# ROAD SAFETY ENGINEERING

### SAFETY AUDIT REPORT

**Project Name:** Kings Parade, Cambridge – HVM

**Audit Stage:** Combined Stage 1 & 2

**SA 2162 – Kings Parade, Cambridge – HVM – Combined Stage 1&2 RSA Problem Location Plan (NTS)**

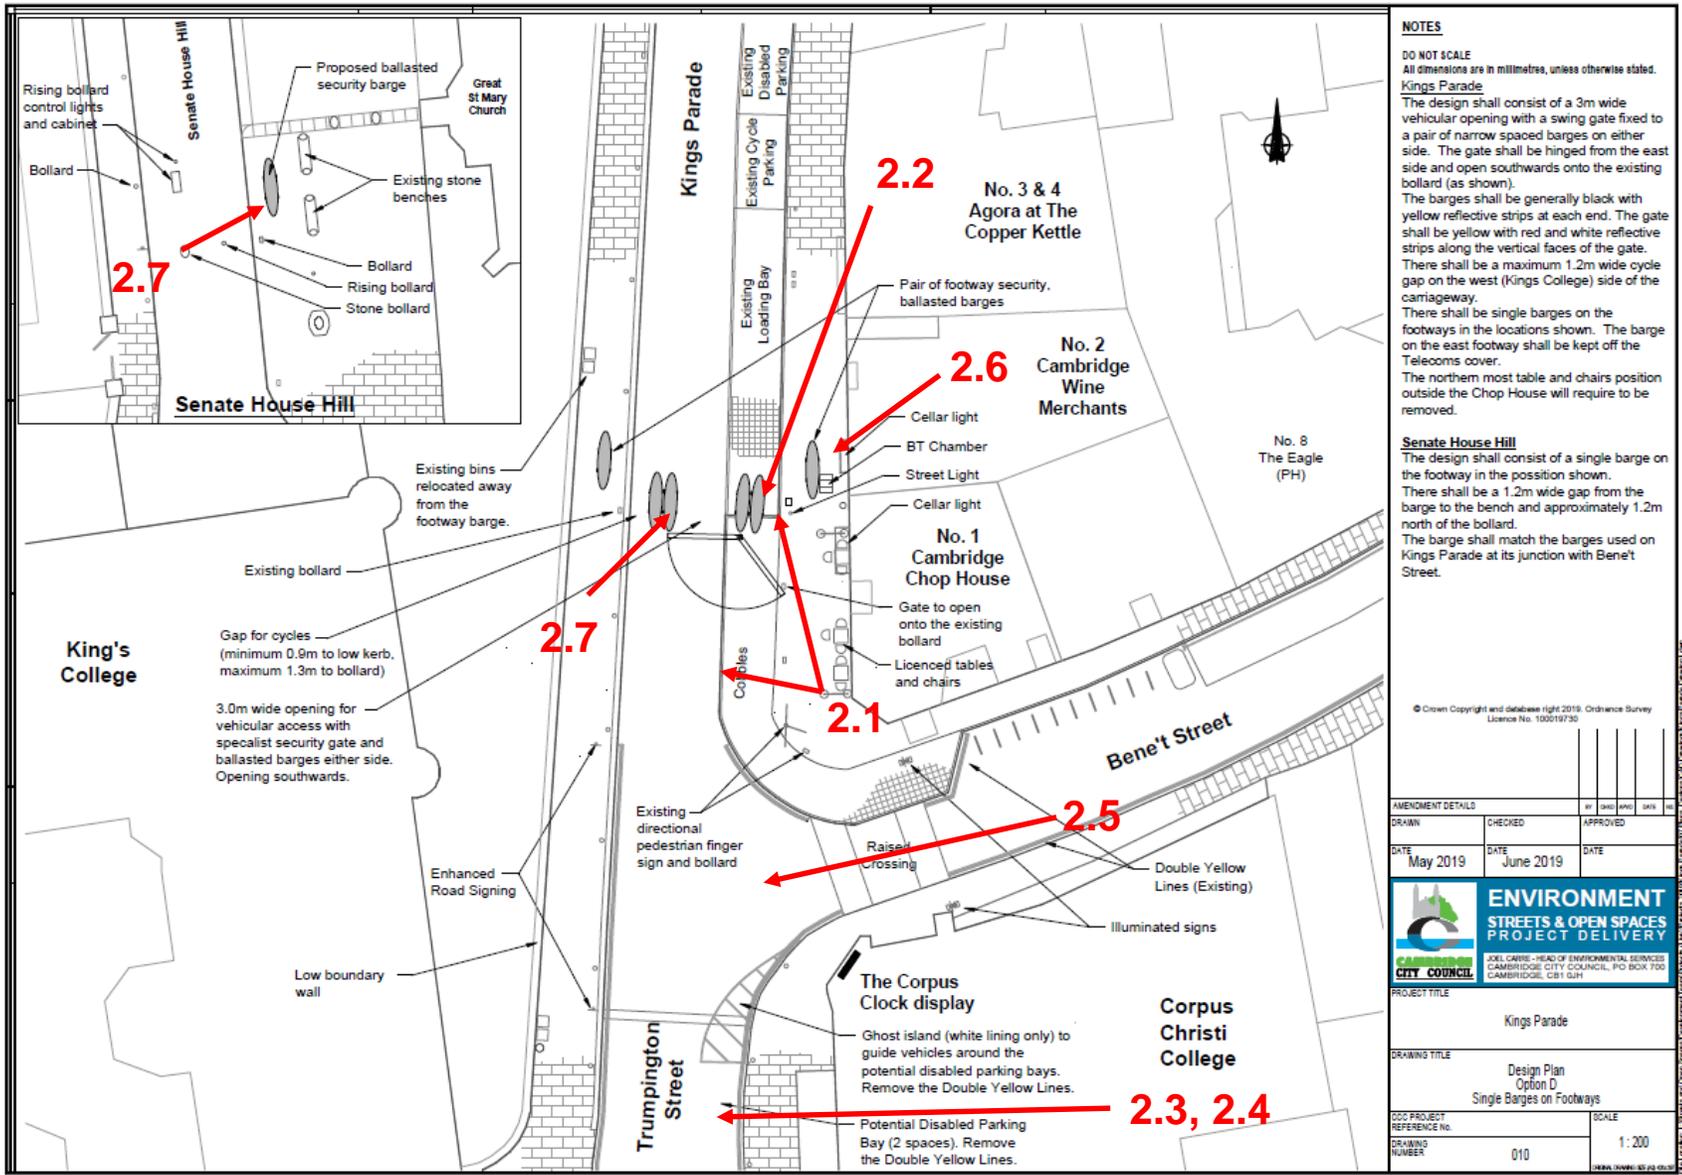
The position of the HVM installation means that, when the gate is closed, southbound cyclists will be required to traverse the raised buildout located to the north of Bene't Street (east side of Kings Parade). The surface of the buildout is formed from granite setts and is bounded by a 40-50mm upstand where it bounds the carriageway. Cyclists traversing this feature are likely to be at increased risk of injury as a result of falling from their cycle.

High two-way flow of cyclists was observed on Kings Parade. When the HVM gate is closed, southbound cyclists will be forced over granite setts (see problem 2.1) and through the narrow gap on the eastern side of the gate (estimated to be less than 1m wide, significantly less than the dynamic envelope of a cyclist). The narrow width means cyclists may choose to ride on the footway, increasing the risk of collisions between cyclists and pedestrians, or choose to cycle through the wider gap on the

western side of the carriageway, resulting in the increased risk of head-on collisions with northbound cyclists.

The proposed disabled bay to the south of Bene't Street may obstruct vehicle movements involving large/long vehicles turning out of the junction, resulting in the increased risk of turning vehicles colliding with vehicles parked in the disabled bay.

Vehicles parked in the proposed disabled bay to the south of Bene't Street are likely to obstruct road users visibility to vehicles on Trumpington Street/Kings Parade, increasing the risk of failure to give way collisions involving road users exiting Bene't Street (with cyclists being most at risk).

Kings Parade is only accessible from the south. Currently there is a generously sized turning head at the northern end of Kings Parade. This allows road users (with access rights) to turnaround and head back south in order to exit via the Trumpington Street/Silver Street junction. The turning head will not be accessible when the HVM gate is closed. This means road users are most likely to use the Bene't Street junction in order to turn around. This could result in the increased risk of collisions involving road users reversing into the path of vehicles exiting Bene't Street as well as NMUs crossing at the junction.

Tables and chairs were observed outside the Cambridge Wine Merchants (No. 2 Kings Parade). If these are still present when the proposed HVM installation is in place they will cause a significant obstruction within the eastern footway, essentially funnelling pedestrians and cyclists through the narrow gap between the gate and barge located on the footway. This

could result in the increased risk of collisions between pedestrians and cyclists.

The Audit Team acknowledge that the proposed HVM installations are to have reflective strips applied. However, full detail of the size and location of the reflective strips have not been provided. If the proposed installations are not conspicuously marked there may be an increased risk pedestrians and cyclists colliding with the HVM installations (both the gate and ballasted barges) during the hours of darkness, resulting in the potential for injury.

It is recommended that a suitable surface is provided along the route cyclists are expected to take and kerb upstands dropped flush to reduce the risk of cyclists falling from their cycle.

It is recommended that the width of the gap on the eastern side of Kings Parade should be increased, with the width provided being appropriate for the speed and volume of cyclists expected.

It is recommended that swept path analysis is undertaken for all design vehicles and the disabled bays removed or relocated as necessary if large vehicles are likely to overrun the bays.

It is recommended that the disabled bays removed or relocated as outside the junction visibility splay.

It is recommended that appropriate turning provision is made on the southern side of the HVM installation to reduce the likelihood of road users using Bene't Street as a turning head or make Trumpington Street one-way in the southbound direction between Bene't Street and Silver Street to negate the requirement for a turning head.

It is recommended that the area in the immediate vicinity of HVM installation is kept clear of table and chairs.

It is recommended that both the gate and ballasted barges are conspicuously marked with reflective bands.
